Planning Board Report
Hancock Lumber Showroom Addition, 258 Main Street
Preliminary Plans for Building & Lot Plan, & Major Site Plan
L & S Limited Liability Company, Applicant
Map 37 Lot 19; CD4 Village Center
Prepared by Erin Zwirko, Director of Planning and Development
Report Date: April 7, 2022; Planning Board Date: April 13, 2022

To: Erin Zwirko, AICP, Director of Planning and Development
From: Steven Johnson, P.E., Town Engineer
CC: Erik Street, Nick Ciarimboli, Chris Cline, Wendy Simmons, Karen Stover
Date: March 25, 2022
Re: Preliminary Major Site Plan Application: Hancock Lumber, 258 Main Street

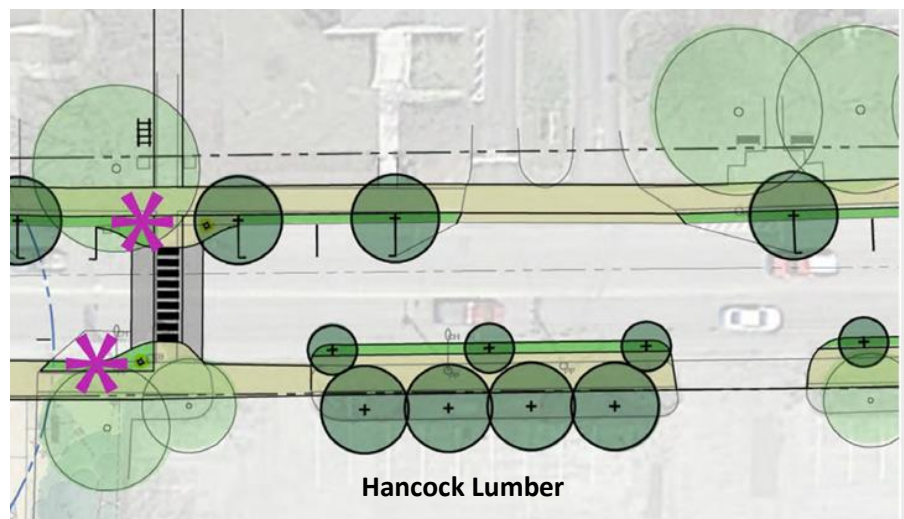
The site plan indicates that a maple tree behind the proposed addition will be protected. There are also other mature trees along the westerly property line and elsewhere on site that should be protected during construction. The site plan should be updated to note those mature trees that will be protected. A tree protection detail should be provided in a future submittal. Additionally, a landscape plan and/or a planting list is necessary to document the revegetation in the area of the bank branch drive through lane.

Further, it should be noted that there are a number of nuisance and invasive plant species along the Main Street frontage would should be removed and replanted with native species in consultation with Town staff.
